GW - 325

INSPECTION

(Drain-lines, Sump, BGT, Site, etc.)

From: Lowe, Leonard, EMNRD
Sent: Thursday, July 30, 2009 1:26 PM
To: 'Friend, George'
Subject: RE: GW-325 Gallup Sump Inspection

PIG RECEIVER SUMP #2

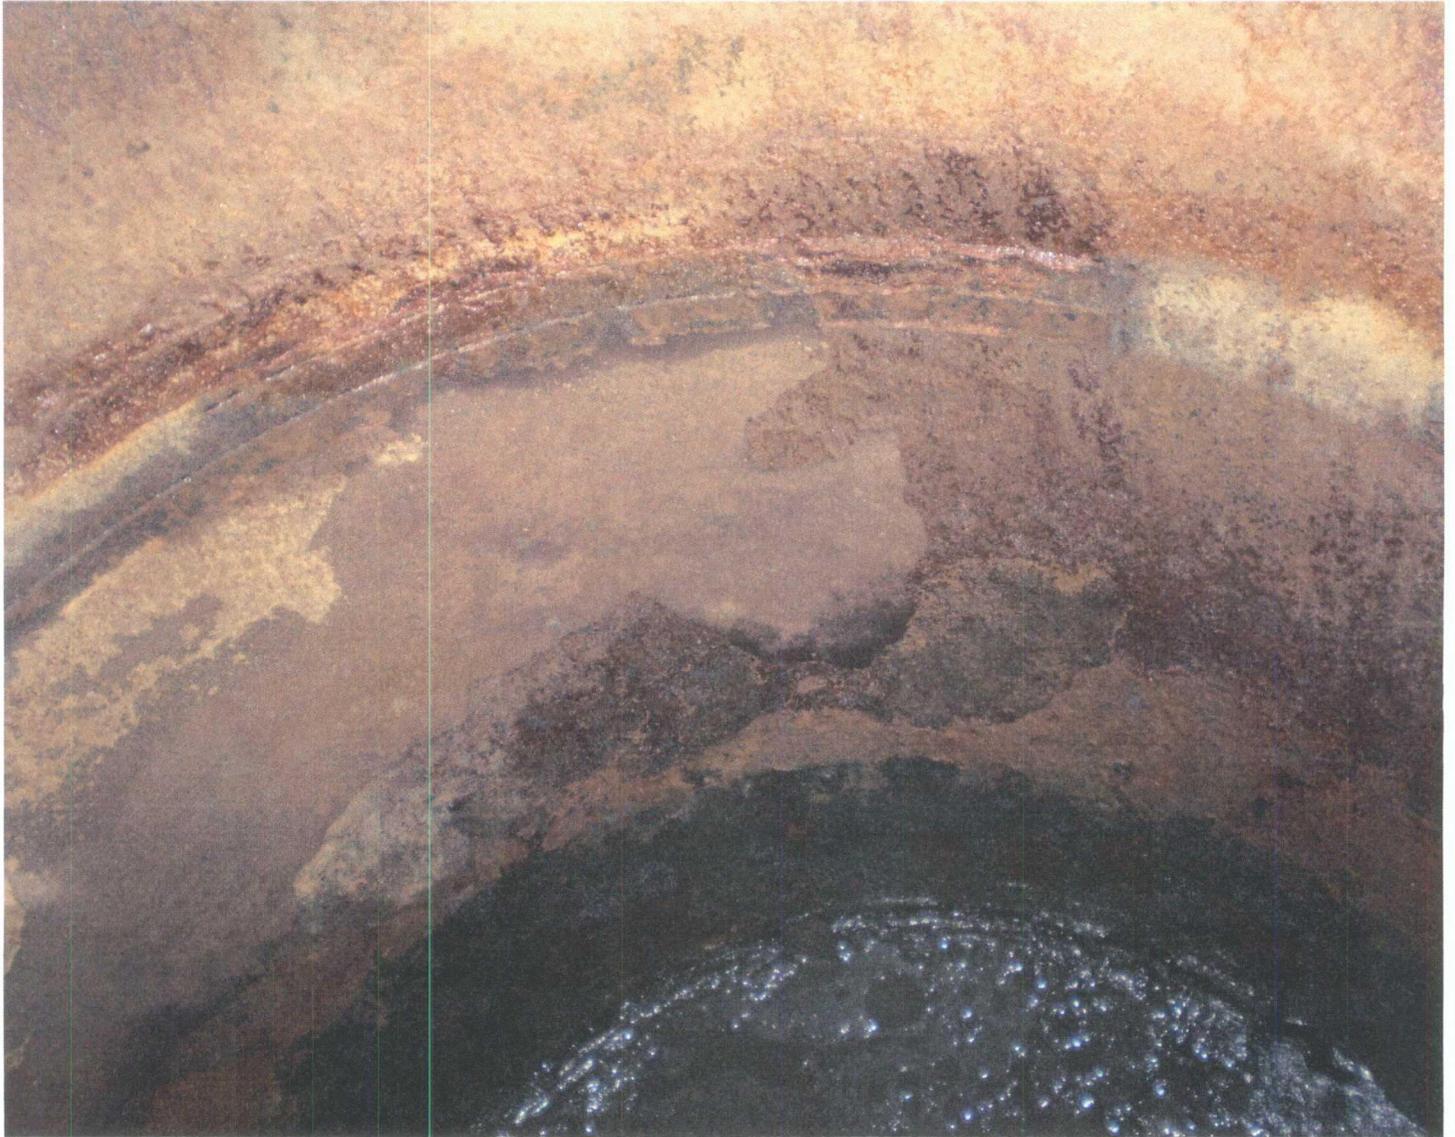
The photo of the TANK identified as Pig Receiver Sump 2 shows a hole in the side walls. Is this the inlet for fluids being discharged in to this tank?
